SUBJECT: TYPE SLV11A1 OVER/UNDER VOLTAGE RELAY

Subject: GE Type SLV11A Relays

SUBJECT: SLV11A STATIC OVER/UNDER VOLTAGE RELAY

FIGURE 1

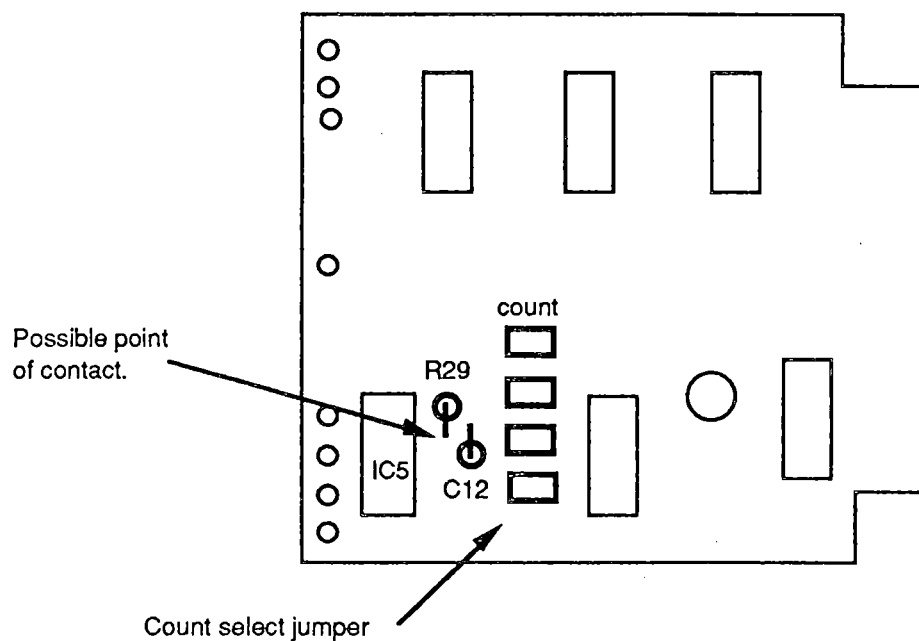
Our lab evaluation of the returned relay indicated that component IC5 was defective on each PC card that had failed to produce an output. On each PC card with a defective IC5 we also found the exposed lead of capacitor C12 was touching the exposed lead of resistor R29. A short between these component leads will result in damage to component IC5, preventing a relay output from the associated phase.

A review of the layout of the card indicated that C12 and R29 are adjacent to a user selection link identified as the "count select". It is possible that C12 can be accidentally pushed into contact with R29 during placement of the count select jumper.

Relays in the field may be inspected for clearance between C12 and R29. Figure 1, attached, shows the location of these components on the threshold detection board. Functional performance of the relay may be verified using the procedure in the testing section of the SLV11A instruction book, GEK-65535.
